Staff Report City of Richmond, Virginia

UDC 2025-20	Conceptual Review	Meeting Date: 7/15/2025
Applicant/Petitioner	Yongping Wang / Department of Public Works	
Project Description	UDC 2025-20 CONCEPT Location, Character, Extent r reconstruction of the bridge over CSX on Arthur Ashe B Norfolk Street and Boulevard West.	
Project Location		
Address: Arthur Ashe Boulevard over CSX		
Property Owner: City Of Richmond Department of Public Works	181	City Garage
High-Level Details:	1806	
A Concept proposal for the replacement of the existing Arthur Ashe Boulevard Bridge over CSX.	1732 A 1732 A 1732 A 1732 A 1724 A 1724 A	CIV Carage
UDC Recommendation	UDC recommends approval with conditions.	
Staff Contact	Ray Roakes, Raymond.Roakes@rva.gov	
Public Outreach/ Previous Reviews	No Previous Review Outreach detailed in Applicant Report.	
Conditions for Approval	Final details on outdoor lighting be sensitive to li compliant.	ght pollution or dark-skies
	Inclusion of permeable hardscape materials who suggested by the Urban Design Guidelines.	ere appropriate and as

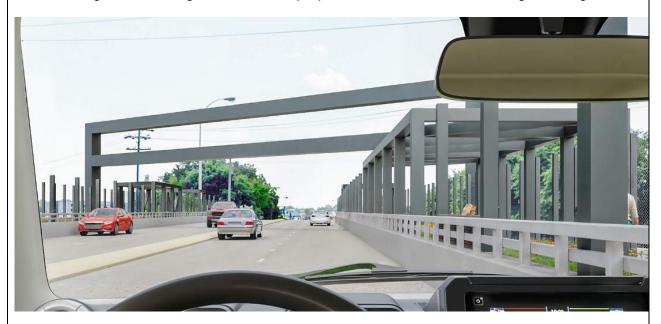
The following is a rendering that shows the proposed view from a vehicle using the bridge.

Staff suggests that the stand-alone vertical elements on the sides may make the structure appear unfinished. The use of the same element (dark metal beam roughly the same size) throughout the design may make the structure appear monotonous. Staff suggests that the design needs a greater hierarchy in elements as well as further attention to the stand-alone vertical elements, perhaps something overhead tying everything together. This could be an opportunity to introduce an interesting design element that not only brings the poles together but the entire bridge.

Staff further suggests that the "Landmark" overhead element may not be quite fully formed yet and needs further consideration. The element has the same dimensions as a sign structure on the interstate highway system. With signage installed -unless very stylized- it will appear as such, which would reduce the effectiveness of the "Landmark" character.
